TO: Madeleine Reinke, Kimley-Horn and Associates, Inc.
FROM: Cynthia Thye, Planner 1
DATE: December 31, 2025
SUBJECT: SP25-119: Lincoln Professional Park L2 - 7 Brews Coffee – Site Plan
Review Comments 02

LINCOLN PROFESSIONAL PARK FILING NO. 1
LOT 2, PARKER, CO
7 BREW - SITE PLAN
COVERSHEET

LINCOLN PROFESSIONAL PARK FILING NO. 1
LOT 2, PARKER, CO
7 BREW - SITE PLAN
SITE PLAN

©2025 KIMLEY-HORN AND ASSOCIATES, INC.
2200 South Syracuse Way, Suite 300
Greenwood, Colorado 80111 (303) 278-2300

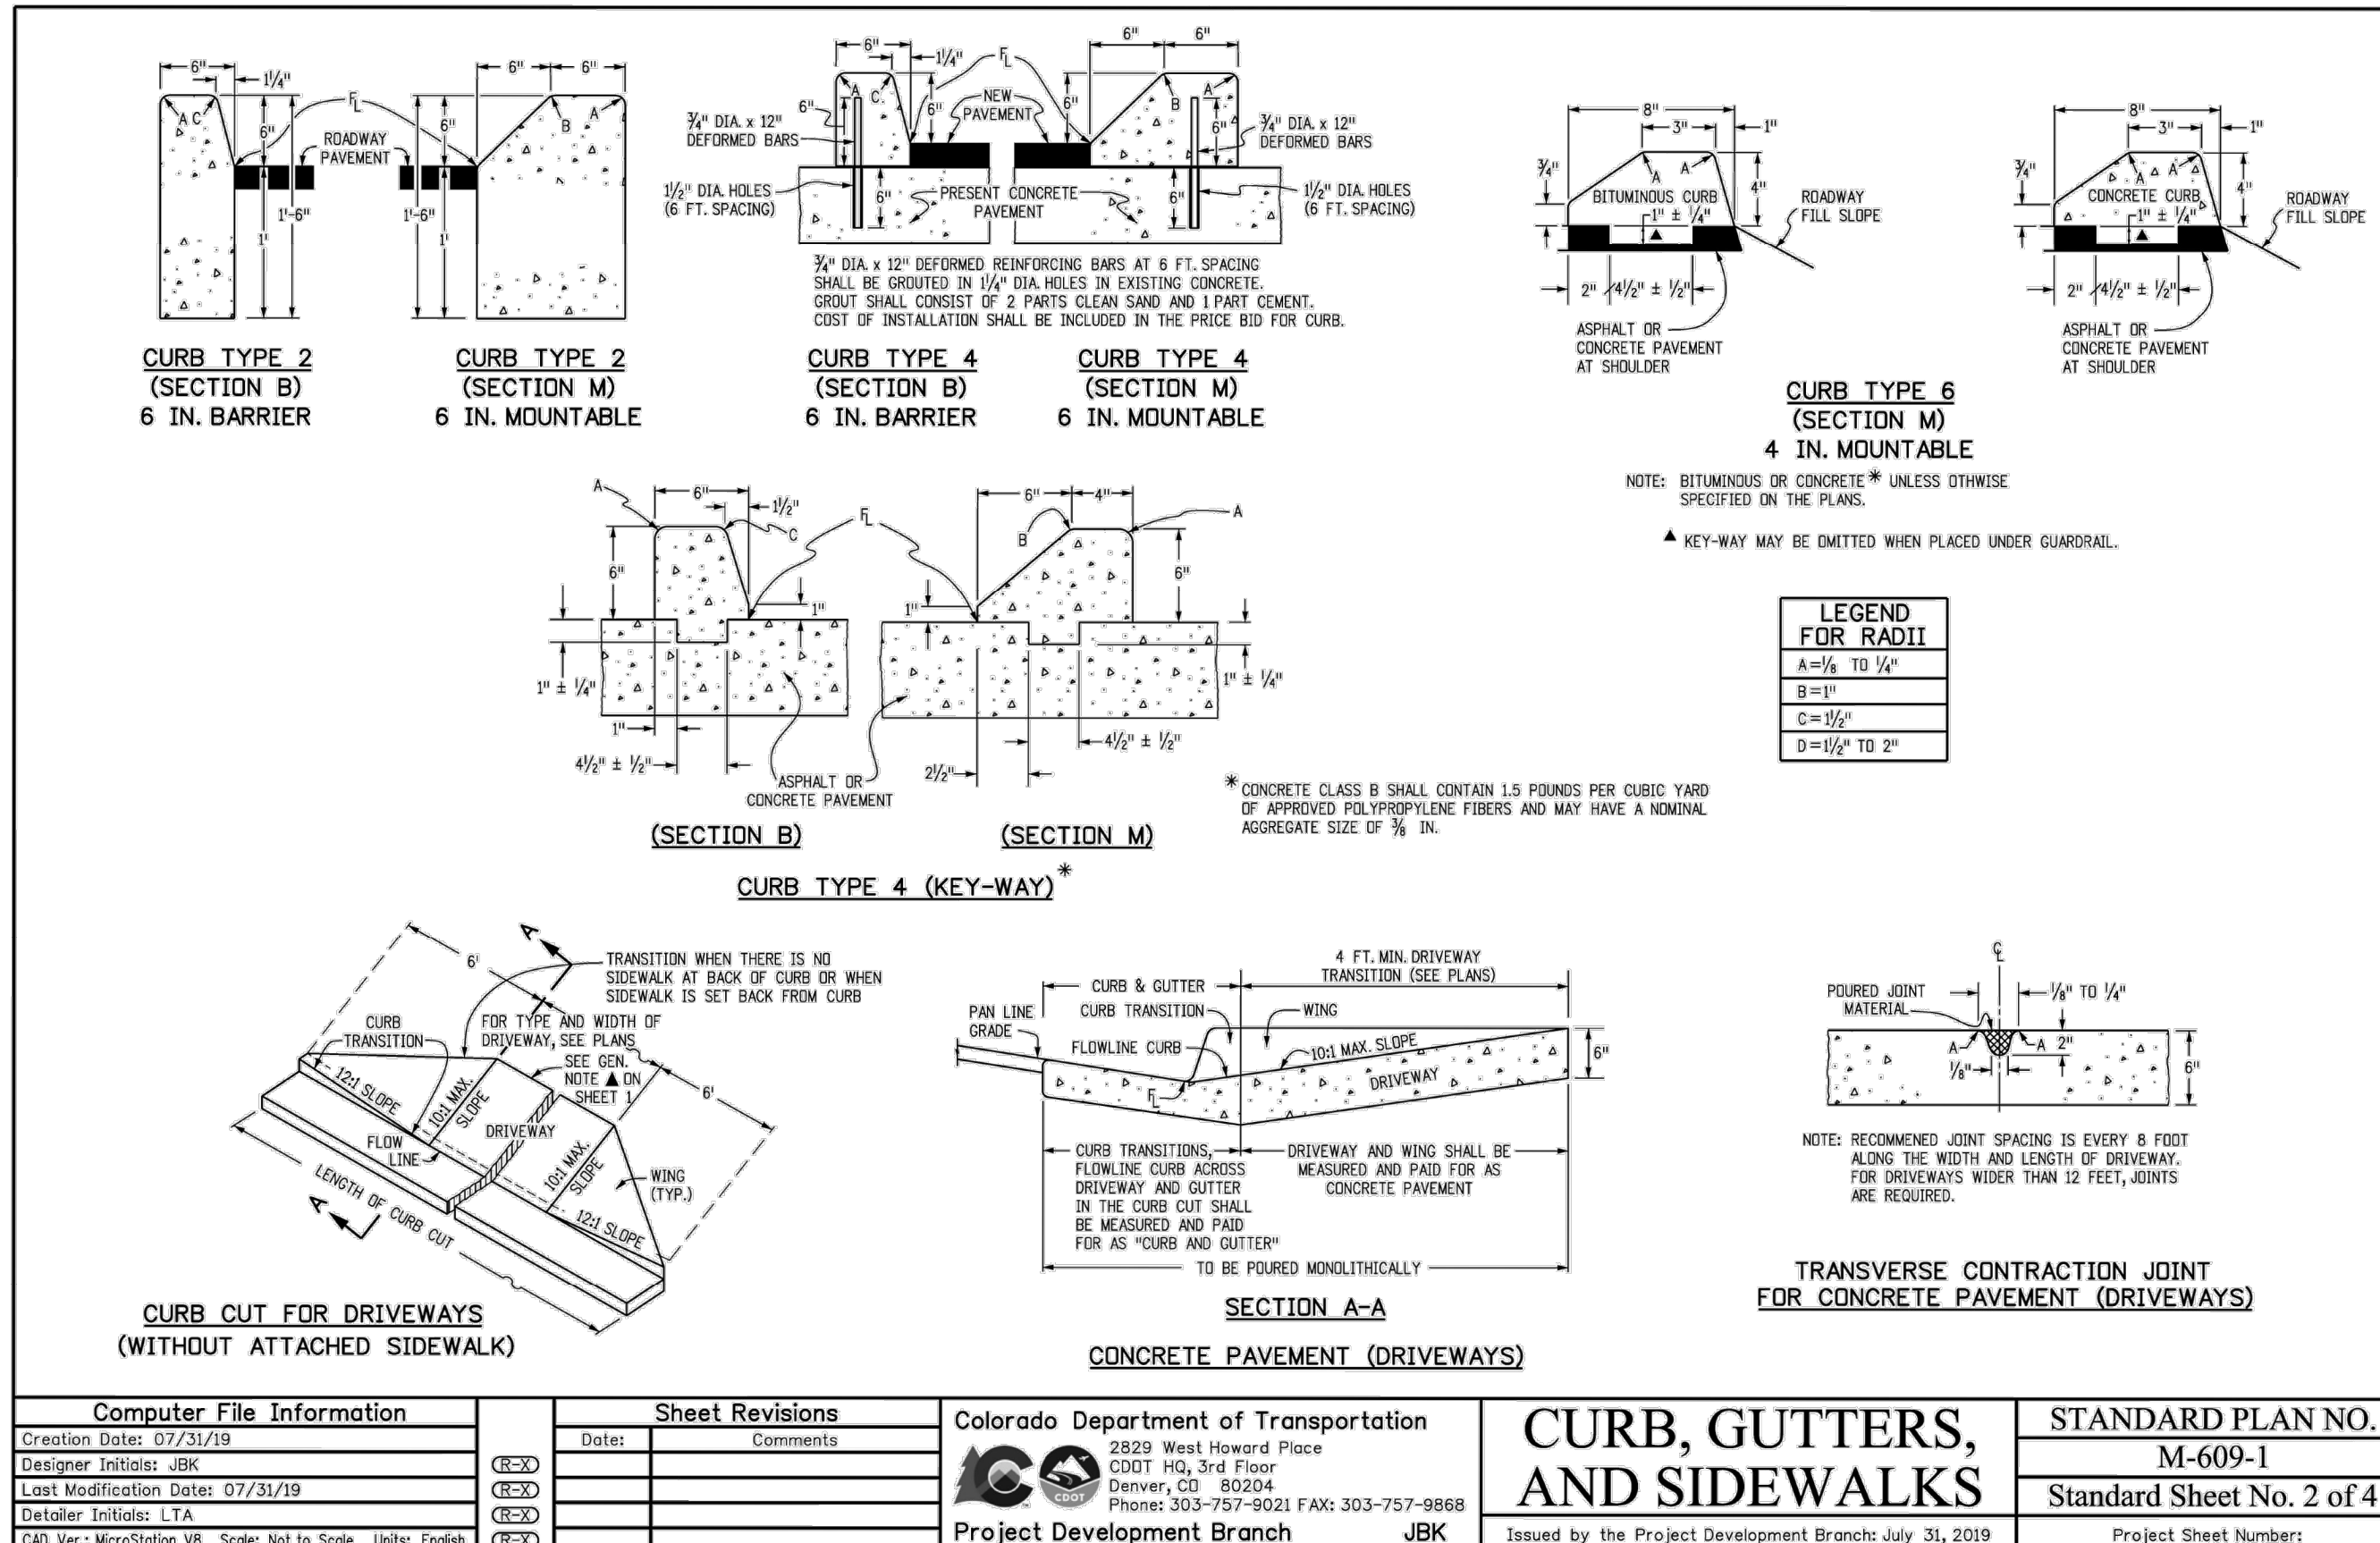
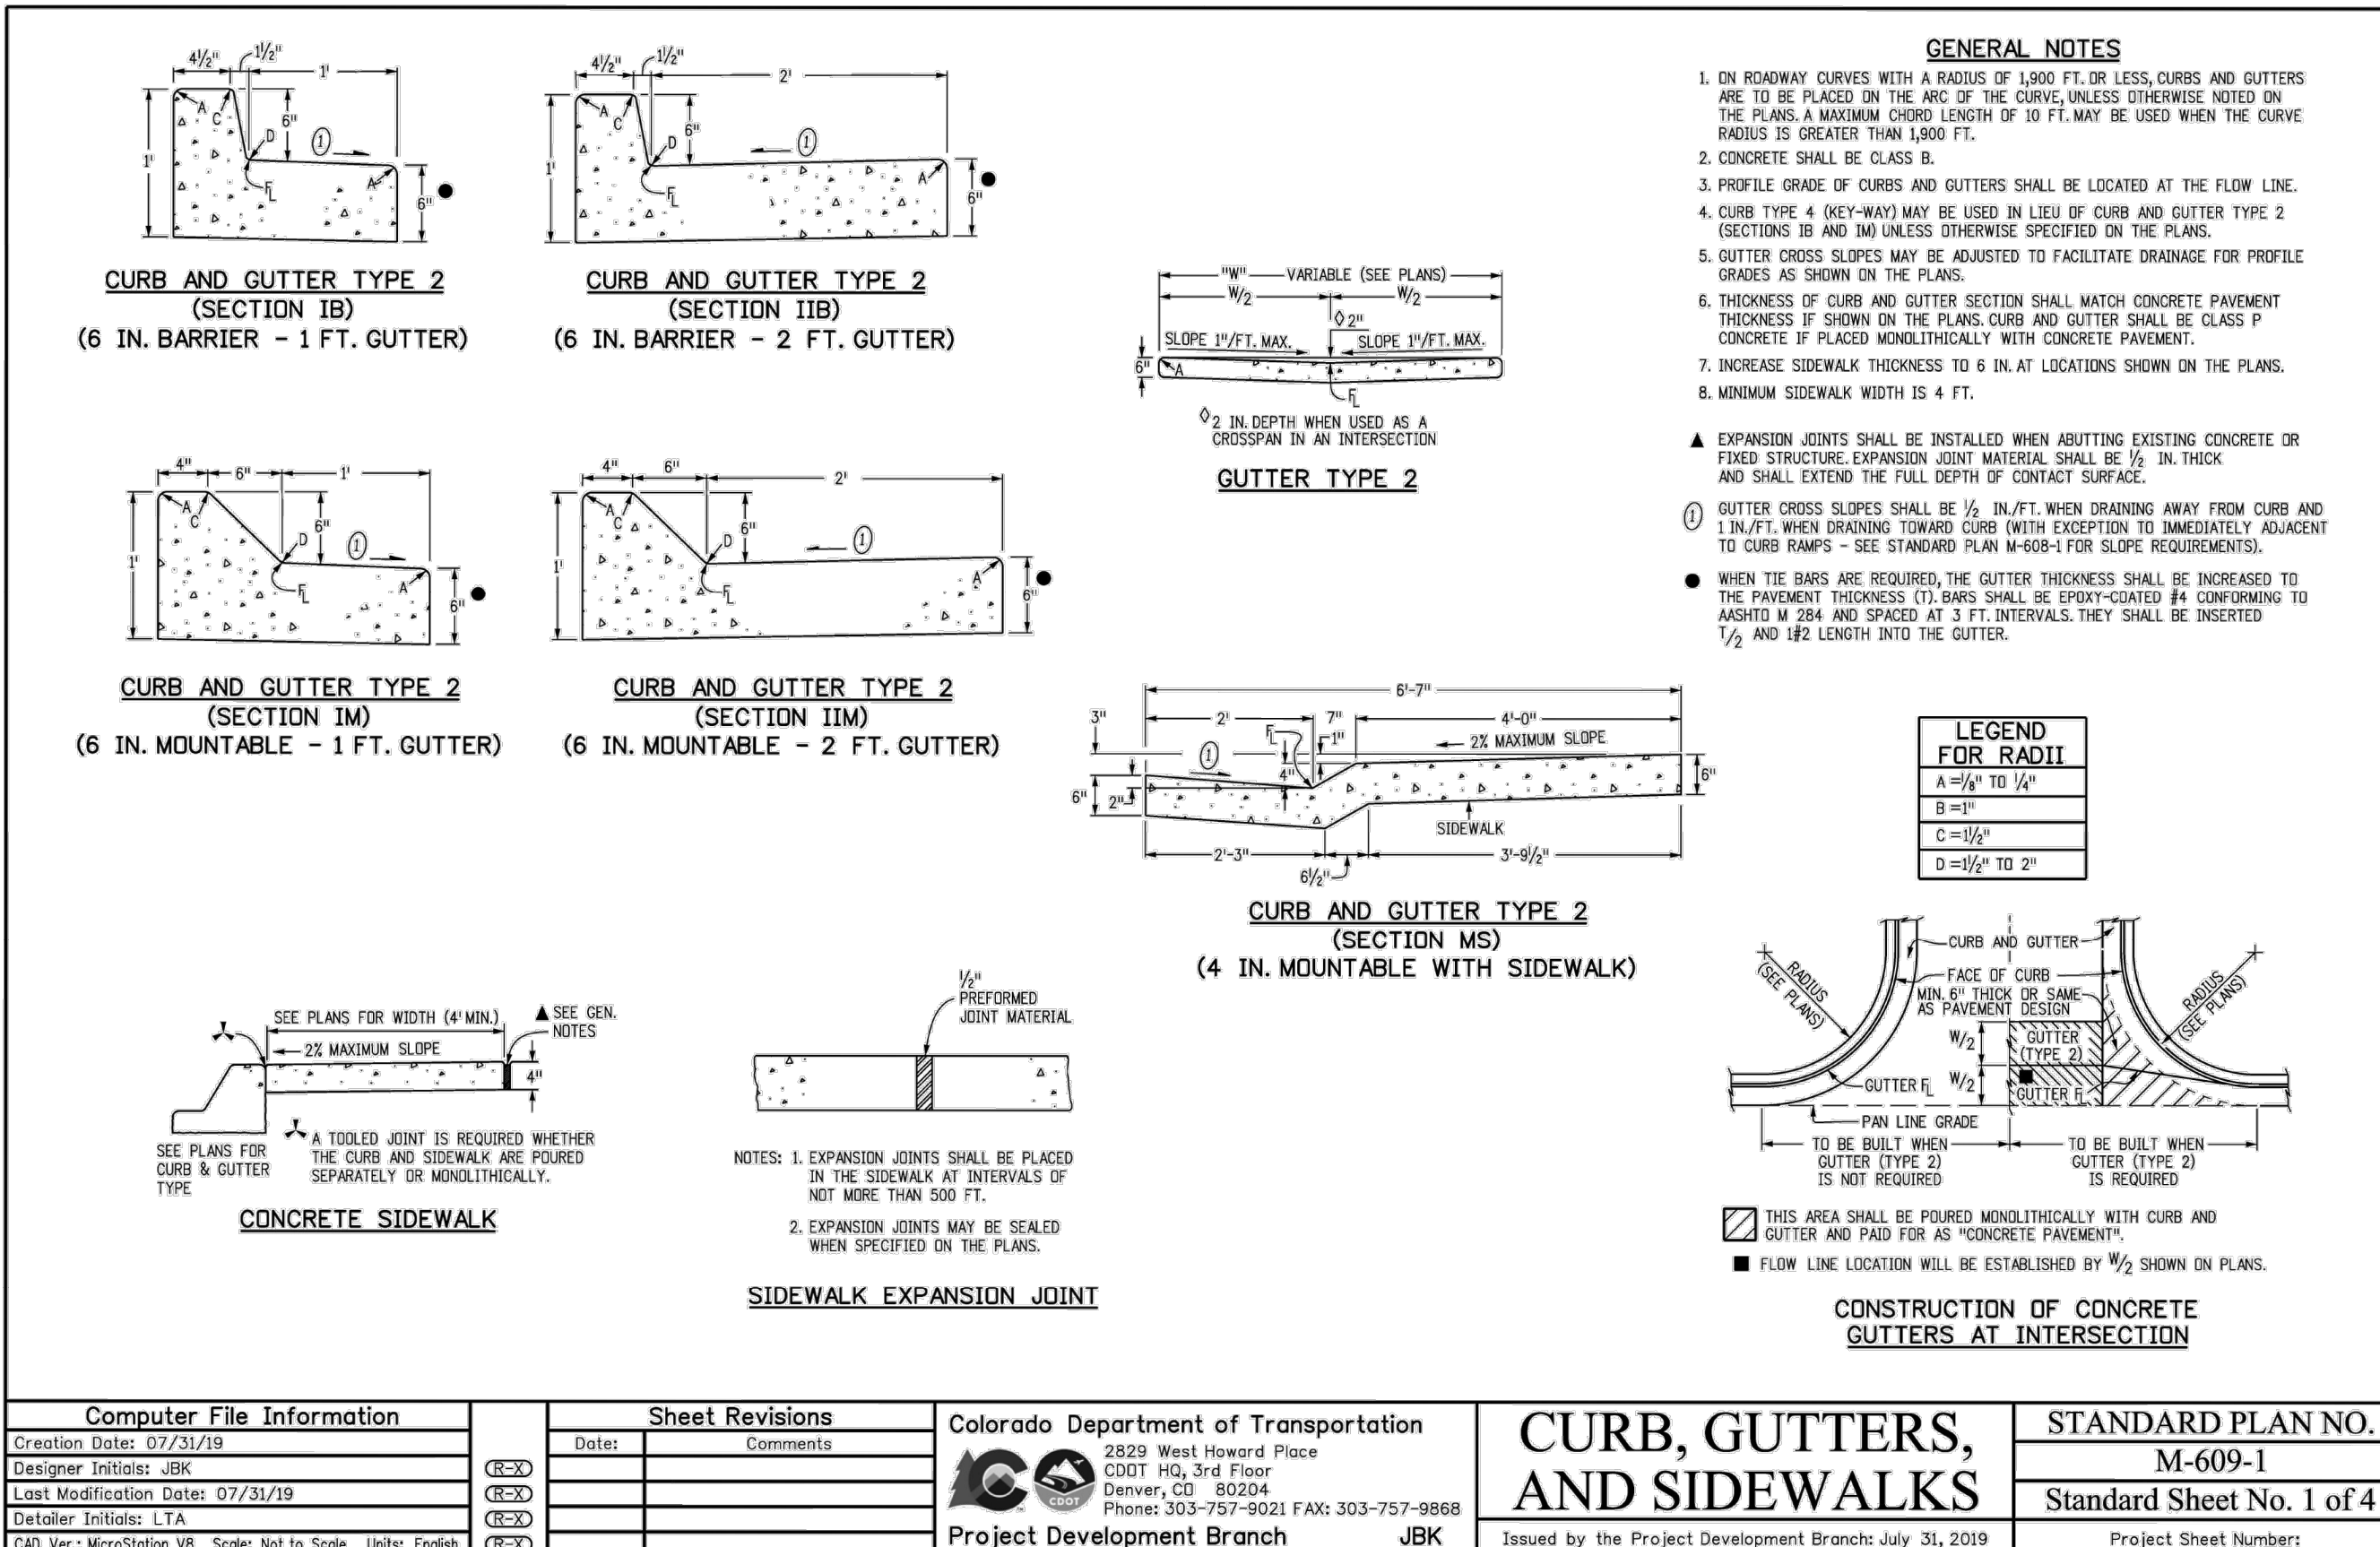
3. **Per LDO Administrative Manual, indicate feet from building to property lines on all four sides. This will also be needed for FLC inspection. Also, add length from building to driveway to ensure DDS compliance.**

Understood, a dimension showing the distance from the building to the property line on all four sides has been added.
